PROJECT: **SECOND FLOOR FIT-OUT (INTERIOR RENOVATION)**
FOR DAUPHIN ISLAND SEA LAB
GMC PROJECT NO. AMOB260001

ADDENDUM NUMBER 2 **August 21, 2026**

PROJECT: SECOND FLOOR FIT-OUT (INTERIOR RENOVATION)
FOR DAUPHIN ISLAND SEA LAB
GMC PROJECT NO. AMOB260001
DCM PROJECT NO. 2026138

SECOND FLOOR PLAN - LIGHTING

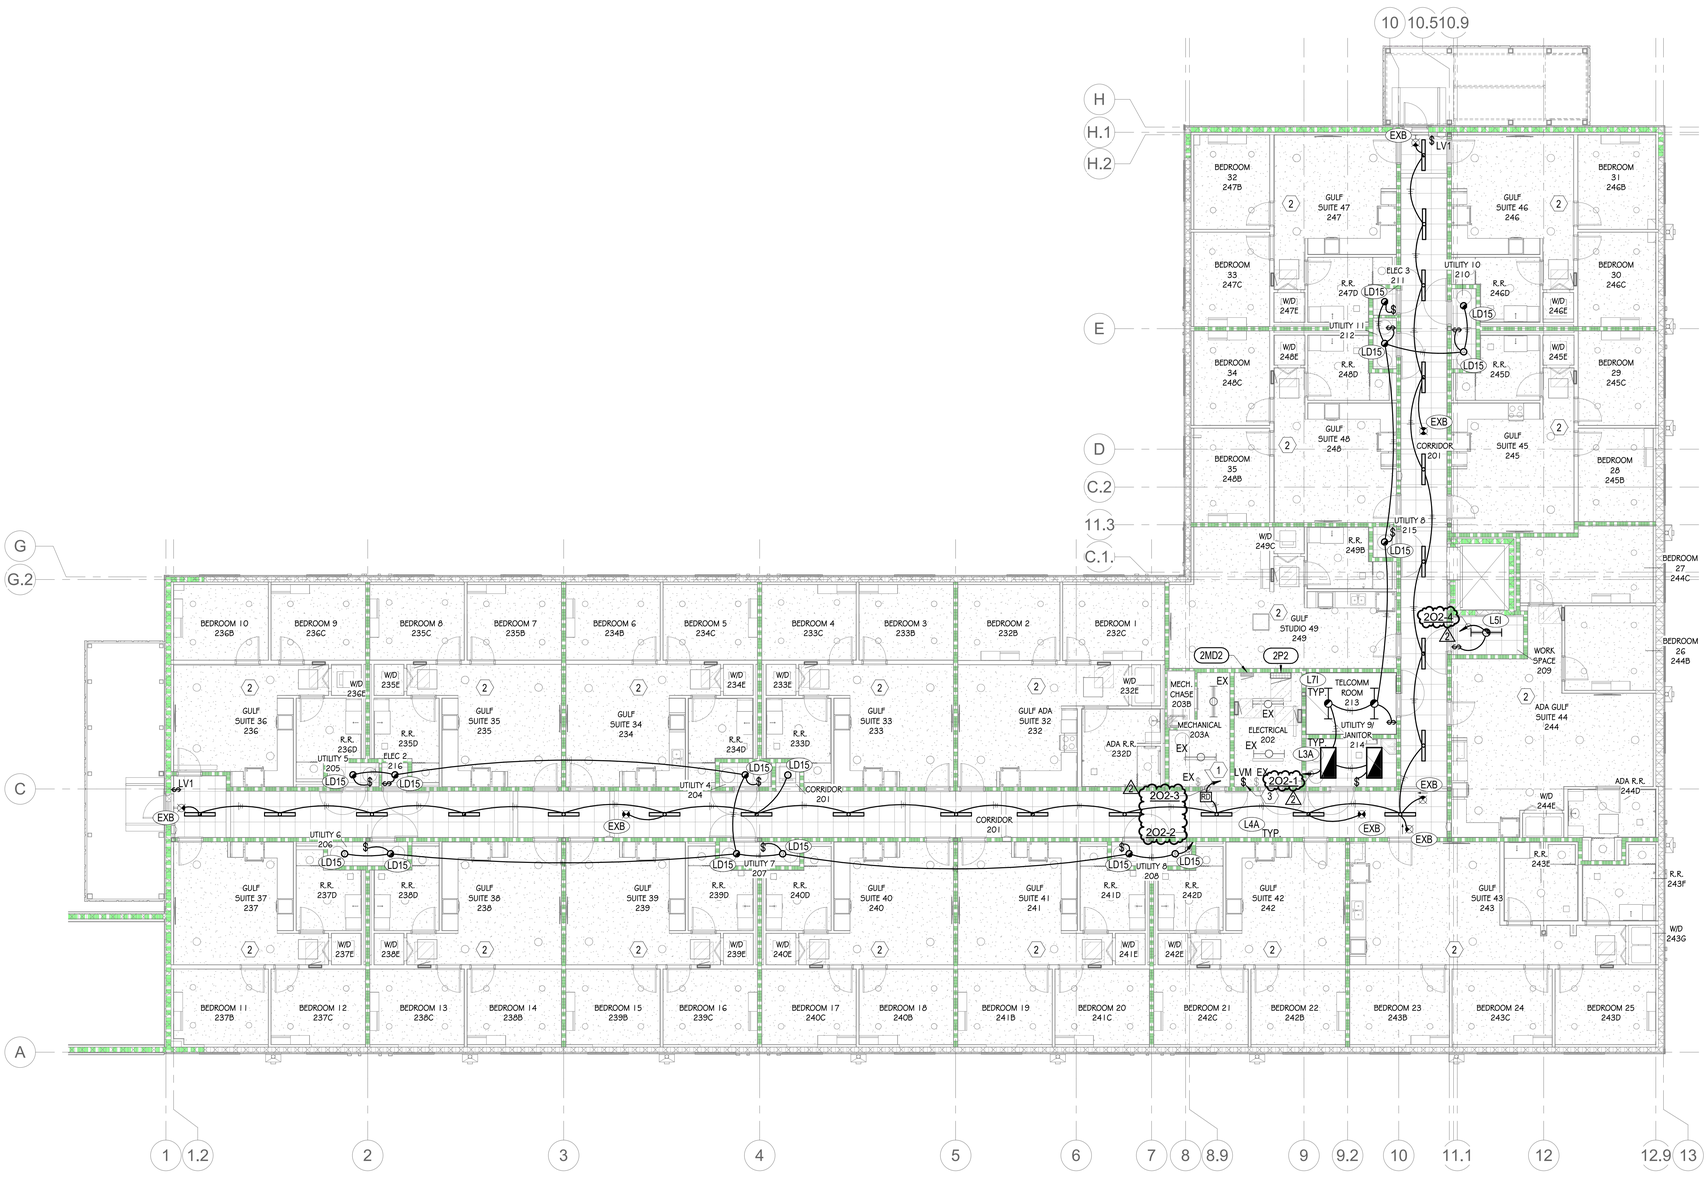
5. **Remove scope to provide and install eighteen (18) through wall dryer vents for the future Second Floor Fit-Out on Drawings A2.03 Second Floor Reflected Ceiling Plan. These vents will be installed in the Second Floor existing wall for plug and connect.**

6. **Remove scope to provide a cost proposal for nineteen (19) through wall exhaust vents for the future Second Floor Fit-Out. Drawings A2.03 Second Floor Reflected Ceiling Plan. These vents will be installed in the Second Floor existing wall for plug and connect.**
